SERVICE BULLETIN

ENGINE - FUEL AND CONTROL - PROVIDE A NEW ELECTRONIC ENGINE CONTROL (EEC) WITH THE
SCN12C SOFTWARE CONFIGURATION - CATEGORY CODE 4 - MOD.ENG-73-0069

V2500-ENG-73-0069

FIGURE 1 LOCATION OF X AND Y PLANES

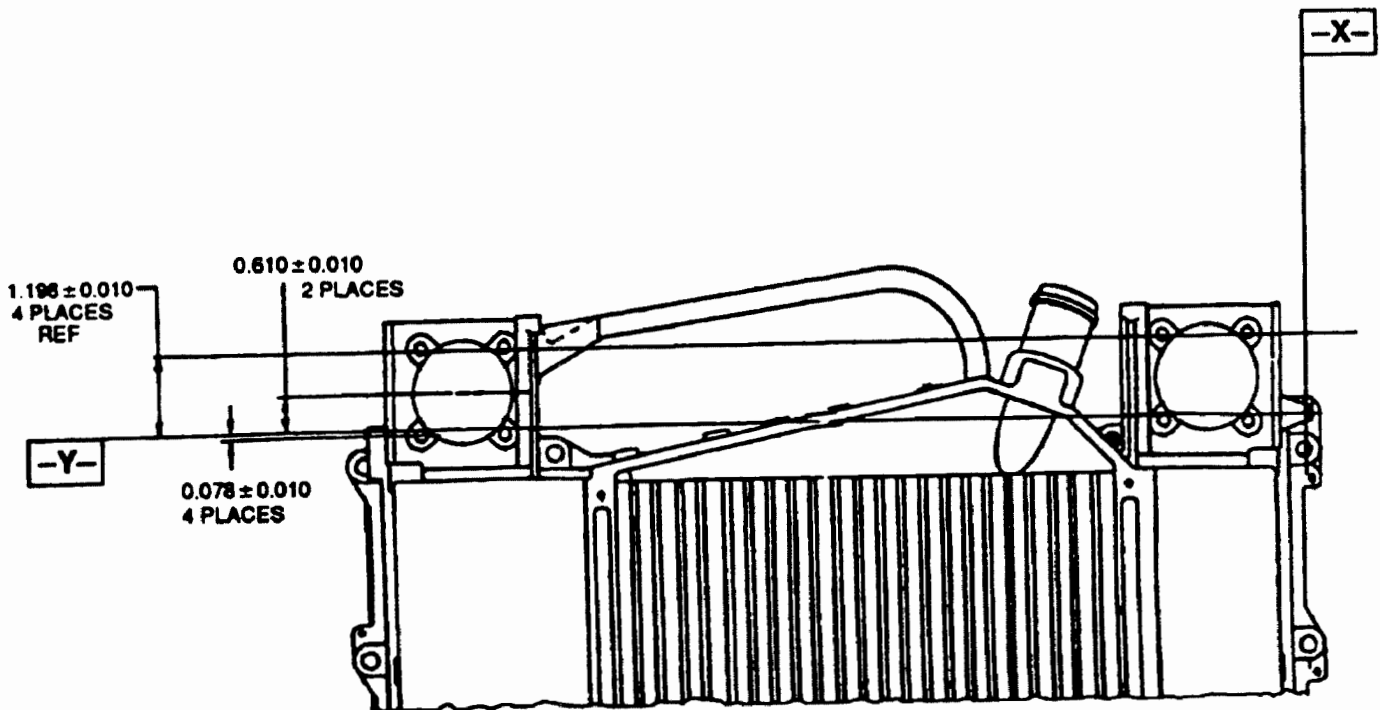
- A. Remove the flame shields as necessary to get access to the two vibration isolators adjacent to the EEC housing handle. To remove the flame shields, refer to DISASSEMBLY in CMM 73-22-34.
- B. Remove the two vibration isolators adjacent to the handle on the EEC housing. To remove the vibration isolators, refer to DISASSEMBLY in CMM 73-22-34.
- C. Refer to Figure 1 to establish X and Y planes.

FIGURE 2 LOCATION OF DRILL HOLES

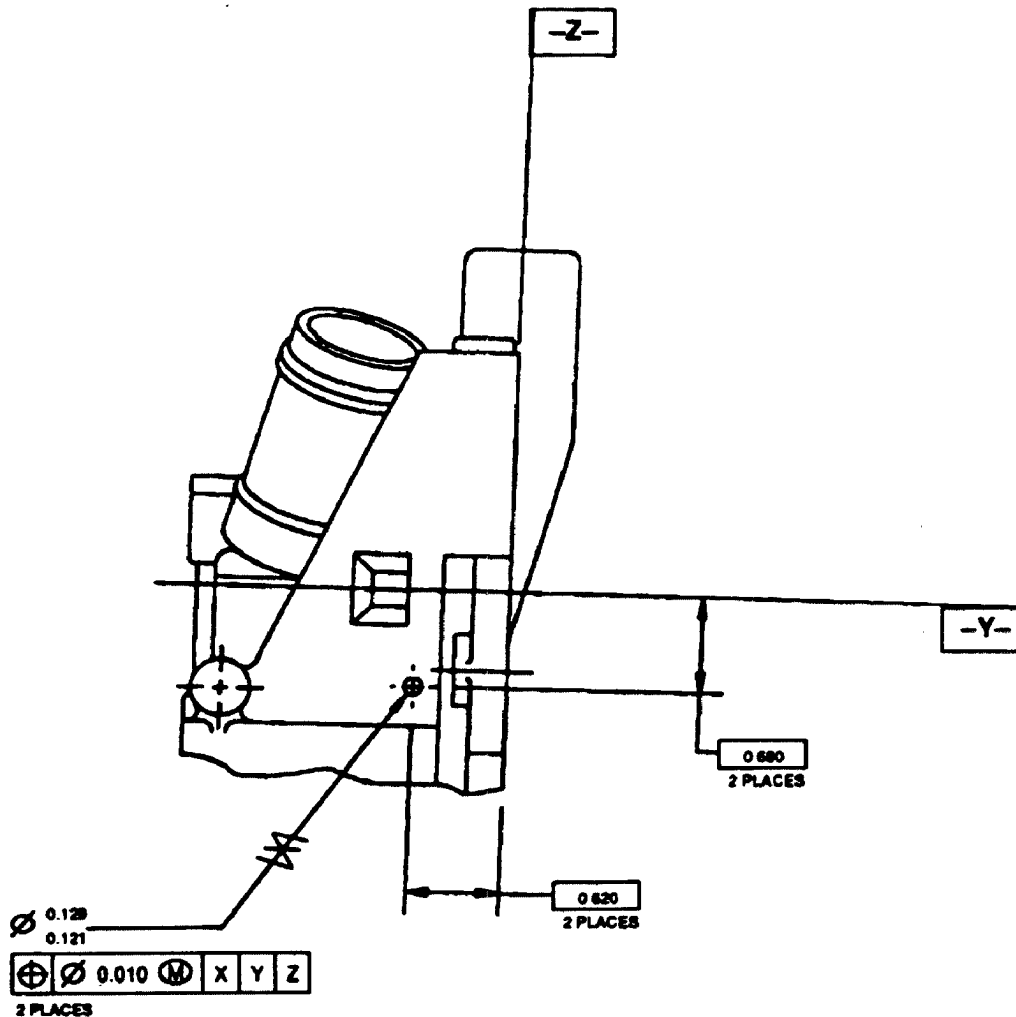
- D. Drill two 0.125 ± 0.004 inch holes in the housing at the locations shown in Figure 2.

FIGURE 3 LOCATION OF DRILL HOLES

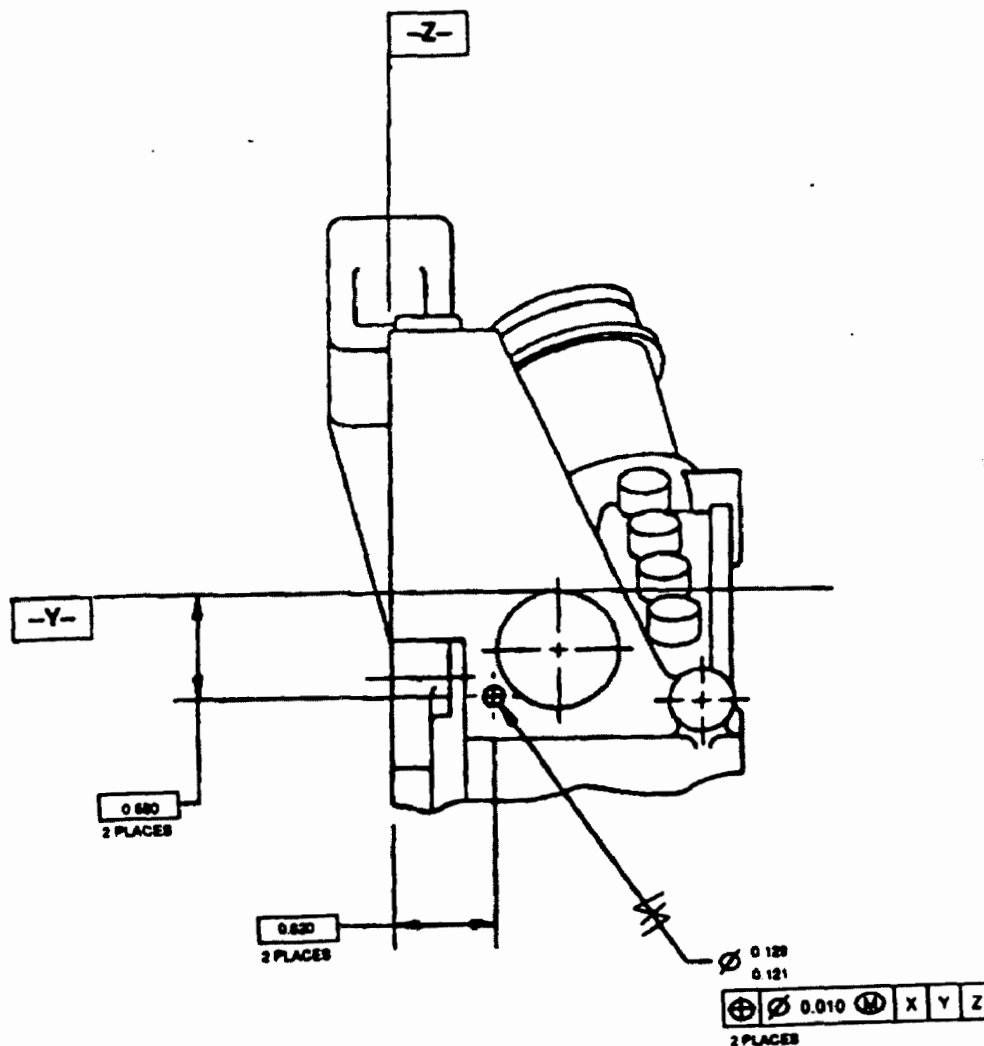
- E. Drill two 0.125 ± 0.004 inch holes in the housing at the locations shown in Figure 3.
